2021 February 22

Cranston Planning Commission  
869 Park Avenue  
Cranston, RI 02921

The Commission should reject the latest changes to the landscape plan's area F proposed by the applicant in their letter of 2021 February 2 and accepted by staff in their memo of 2021 February 23. The new condition 6 is wholly inadequate to provide any buffer for abutters to the southeast as recognized by the Commission's landscape architect in her letter of 2021 January 18. "...[T]he proposed planting along the fence seems to have minimal initial or long term buffer value." How does the use of area D plantings change that determination?

FIGURE 1 - PROPOSED GROUNDWATER MONITORING WELLS AND SURFACE WATER SAMPLING LOCATIONS

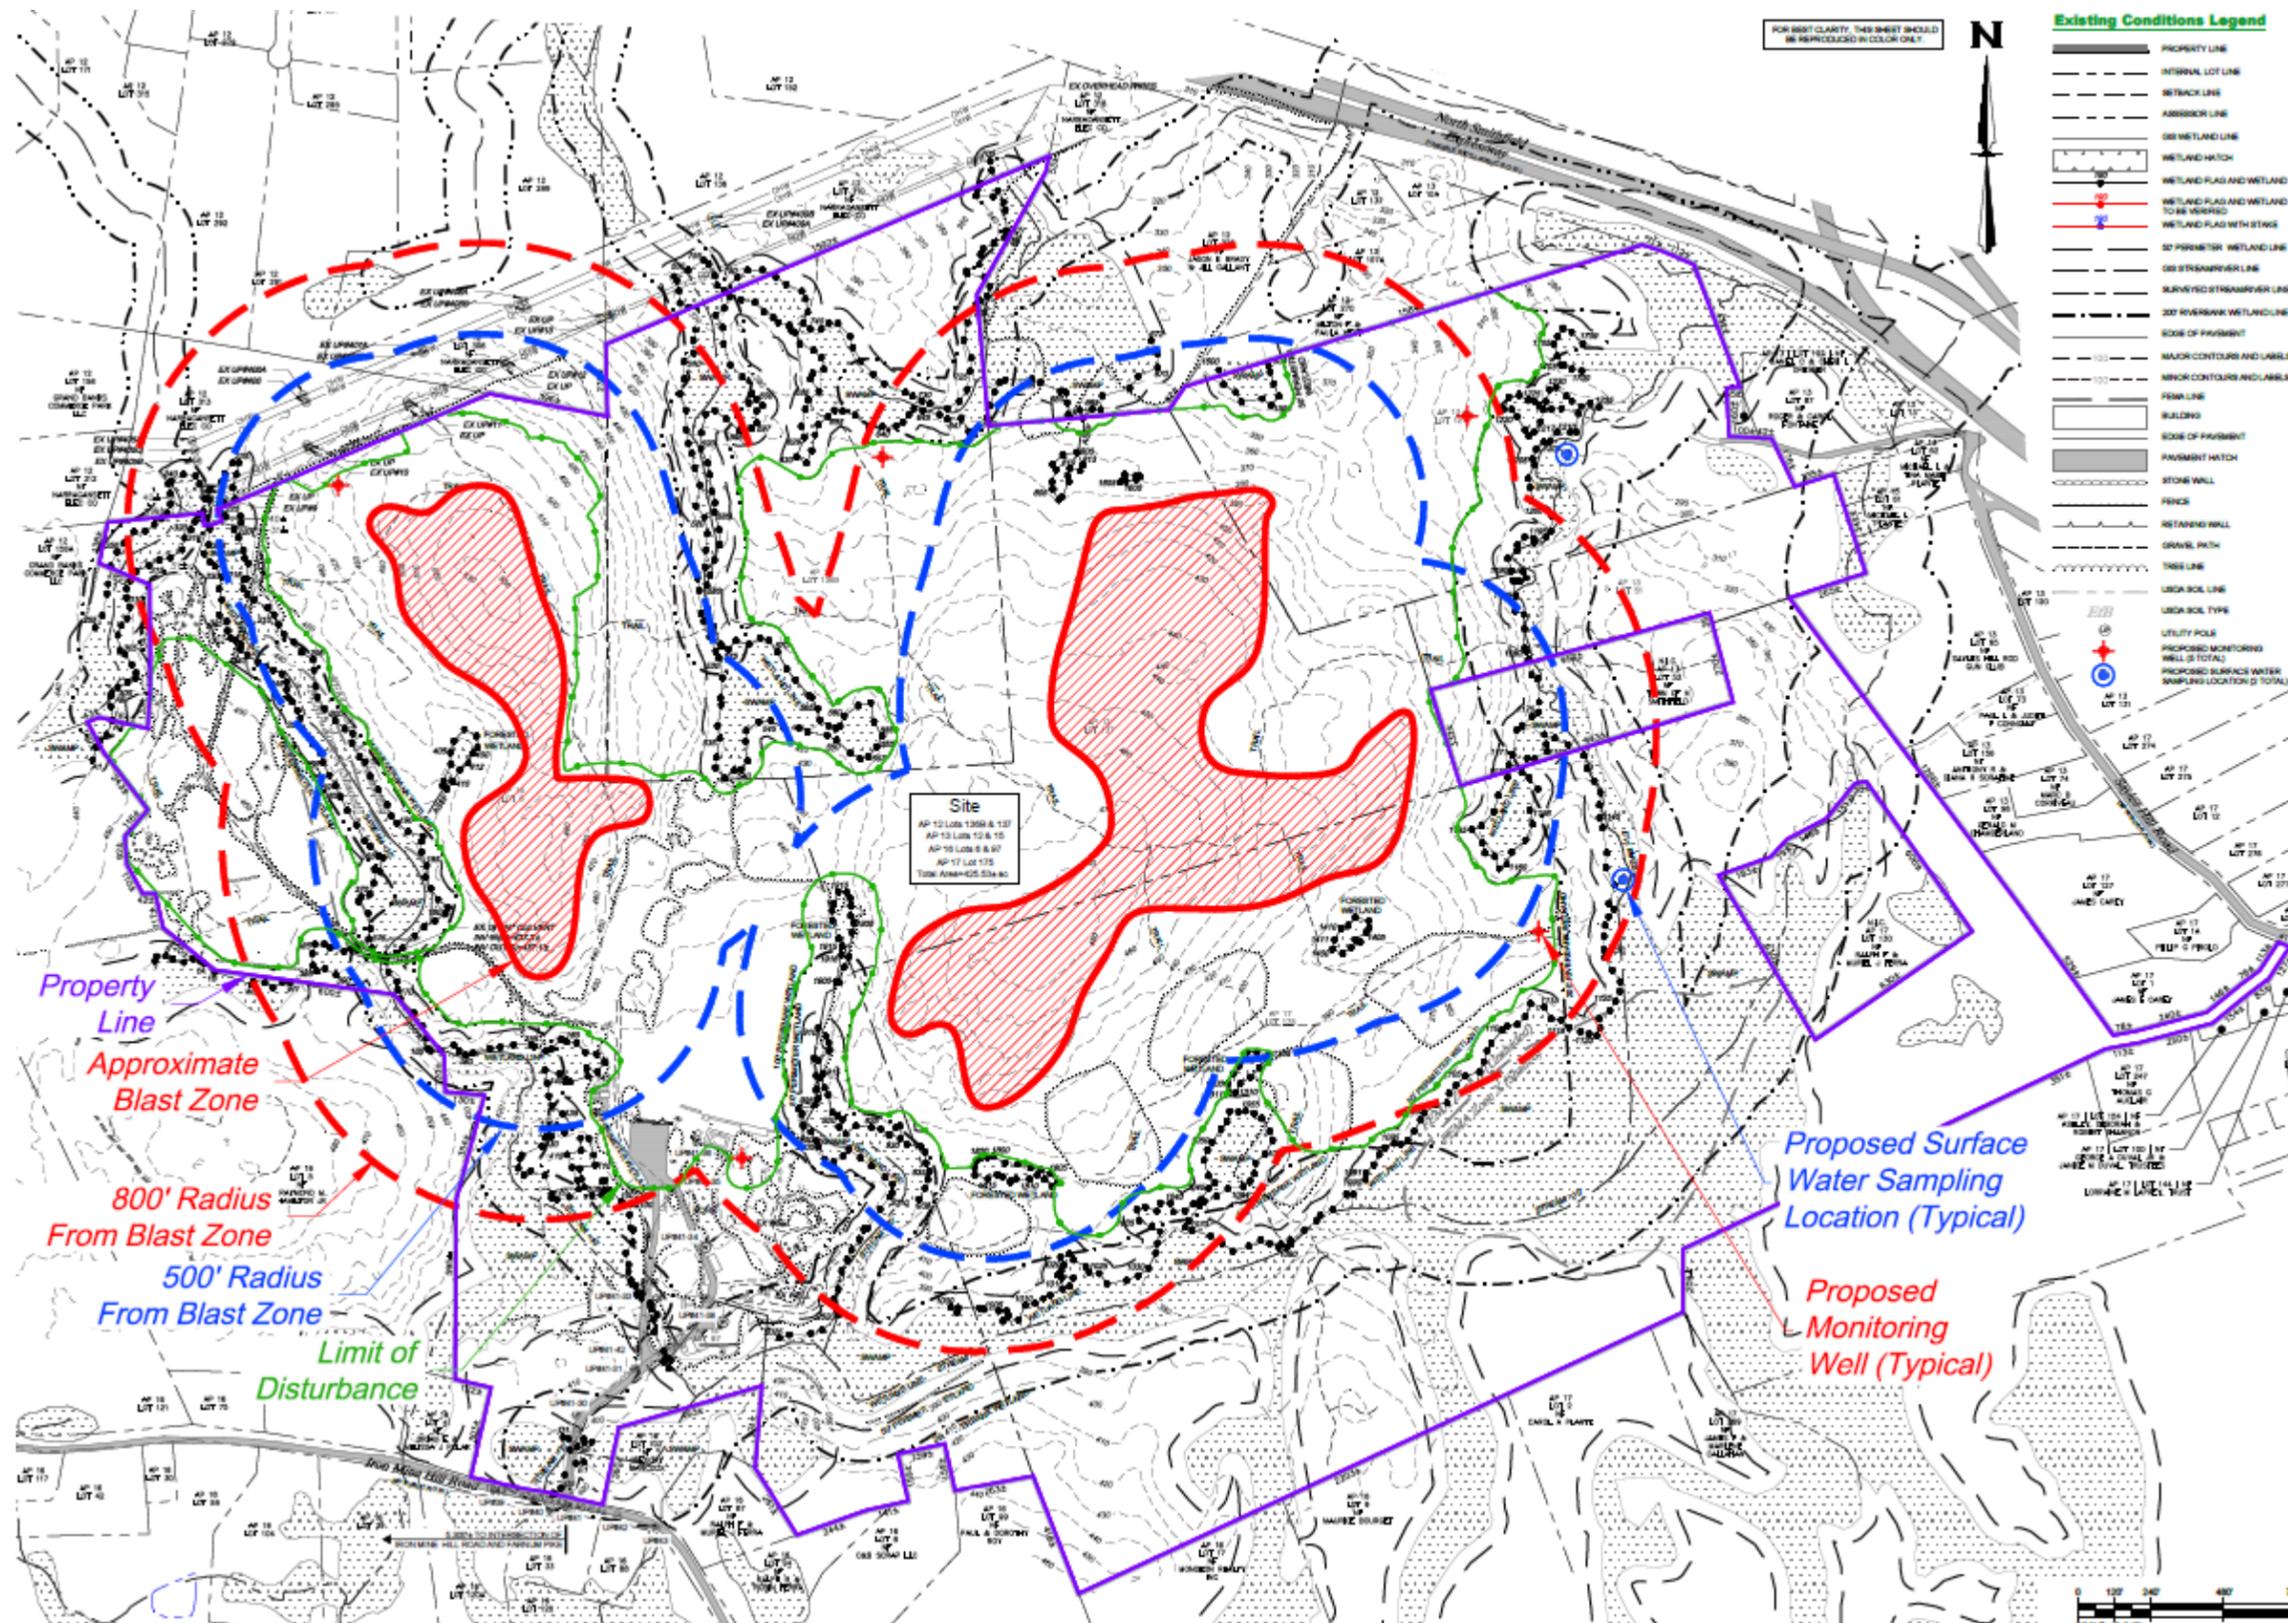
**Condition #18** - *Applicant must satisfy the City of Woonsocket Water Department regarding their letter dated March 4, 2020, and, the City's peer review needs with evidence to such submitted with Final plan application.*

**Proposed Actions** – Subject to review by Pare, RPS will conduct surface water sampling of Spring Brook. Surface water sampling will consist of collection of grab samples at two locations on Spring Brook: at the source of the brook (the outlet of the large on-site wooded swamp wetland); and from the brook channel where it exits the project property. The proposed sampling locations are depicted on **Figure 1**.
